Re: Public exhibition of Melbourne Metro Project Early Works Plan and Precinct Development Plans

5 CBD South Precinct Development Plan submission (Town Hall)

5.1 Degraes Street underpass - also known as 'Campbell Arcade'

Figure 1: Area outlined in red highlights proposed impact on Campbell Arcade

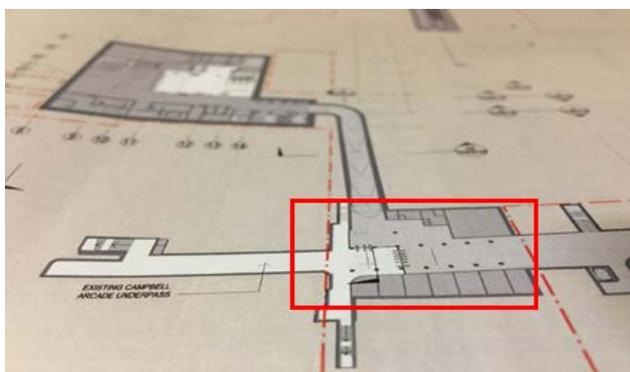
The National Trust acknowledges that the cultural heritage impacts on the heritage-listed Campbell Arcade (VHR H1083 HO649) are a more recent design response and were not discussed or interrogated during the EEs process. At a meeting between National Trust, MMPR and CYP in December 2017, it was noted by CYP that ‘the proposal to connect the Town Hall to Flinders Street station via Campbell Arcade aims to utilise existing infrastructure that is somewhat currently underutilised, particularly in comparison to access points at Elizabeth Street and Swanston Street’. As shown in the plan above, the proposed connection would require access to Campbell Arcade, resulting in the removal of three shops on the eastern side, and the construction of a ticket gate which would removal free public access to the space.

The National Trust is strongly opposed to the proposal as it stands. The National Trust believes that Campbell Arcade has two levels significance, 1) as an example of post-war transport infrastructure (and the first major public infrastructure project in the city following WWII), and 2) the contemporary socio-cultural significance of the tenancies and use as an art space over the past two decades. We believe that for these reasons, it is important that no shops are removed from the arcade, that the symmetry of the arcade is maintained, and that the space remains freely accessible to the general public.

The National Trust would like to see all alternative options explored before this section of the Development Plan gains approval. Our recommendation would be to move the ticket gate to reduce impacts on the number of shops free accessible to the public, and to relocate the walkway connection to the larger shop in the south-eastern corner (currently a newsagents) so multiple shopfronts do not have to be removed, and the symmetry of the arcade can be retained.
